# Technical Service Bulletin

**92 Headlight washer jet does not retract**  
**92 22 29 2065982/1 February 8, 2022.**

| Model(s) | Year | VIN Range | Vehicle-Specific Equipment |
| A6       | 2019 | All       | Not Applicable             |

*Figure 2. Old version cover spring clip.*

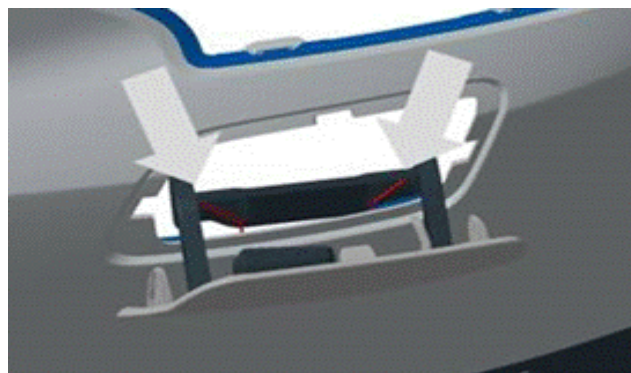
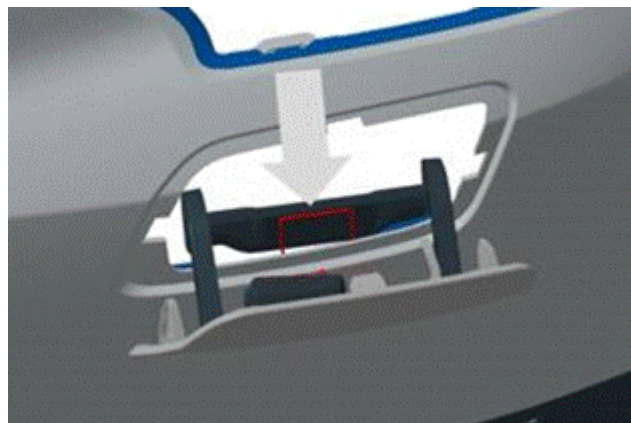
This issue may be due to a headlamp washer system nozzle cover return spring exerting too great a force and may prevent the nozzle from retracting.

If the symptom described in this TSB is duplicated, make an attempt to relieve the pressure exerted on the headlamp washer system nozzle cover with your finger. If the nozzle retracts on its own check the cover spring clip version. Figure 2 shows the old version which has been found to exert excessive pressure and prevent smooth nozzle retraction.

Figure 3 shows the improved spring clip with reduced tension.

A new headlamp washer system nozzle cover return spring with less force has been implemented in production.

If the old spring clip version is installed and the nozzle retracts on its own after relieving the cover pressure, replacing the spring clip may solve the problem. Replace the spring clips for both the left and right sides in this case. Only the improved version spring clip is available.
